**CGISS EME response to FCC correspondence 24662 FCC ID AZ489FT4855
January 22 2003**

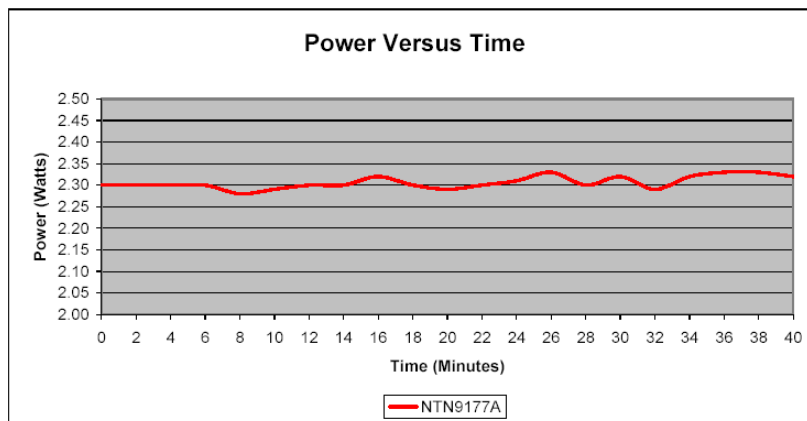
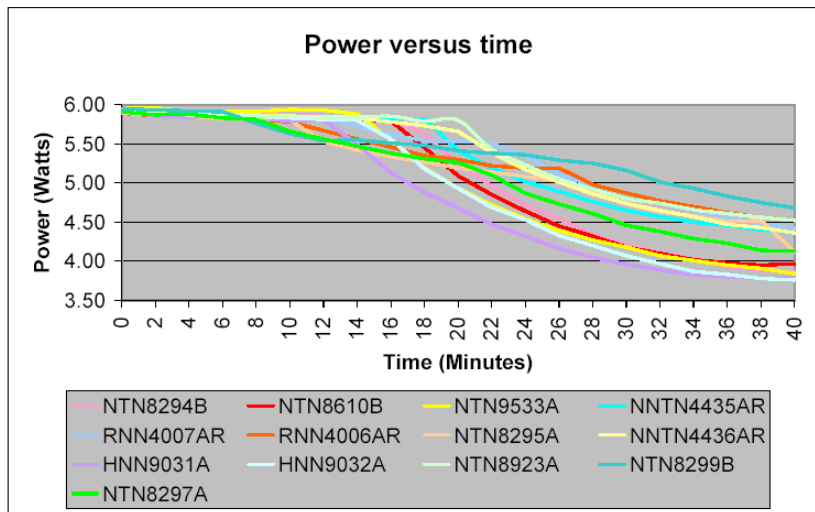
1) Clarification of power droop. Droop data provided for two batteries does not seem to agree with before/after power data assuming 22 minute scan times. Please clarify.

R1.) The power slump reported is accurate and is indicative of the method used to measure the before and after power compared with the method used to measure power versus time. It is generally accepted that a radio's PA should not be allowed to transmit into an open load. For this reason before and after power is measured by removing the antenna and connecting the measurement equipment to the device after "de-keying" the transmitter. The power versus time data submitted for the two batteries mentioned was taken while the DUT was continuously connected to the measurement equipment during the test. Based on the short-term partial recovery of the battery during the "de-keying" process and depending on the specific DUT, it is possible to see discrepancies between before and after power results compared with the power versus time results.

Photo 4. DUT with NTN9179A carry case against the phantom w/ attached RSM

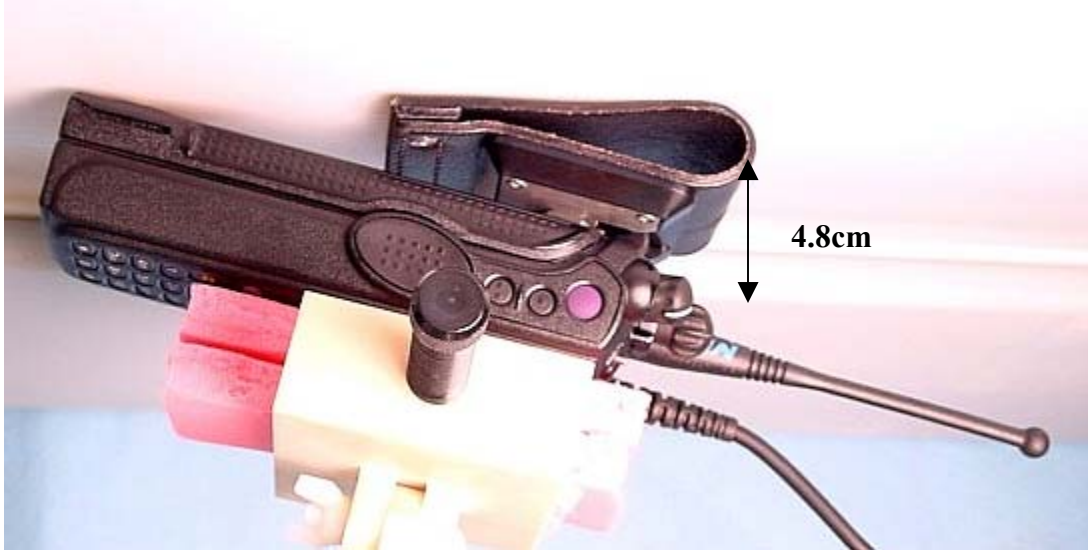
6) Photographs showing all BW accessories in test configuration.

R6.) Please see below for the additional photographs requested.
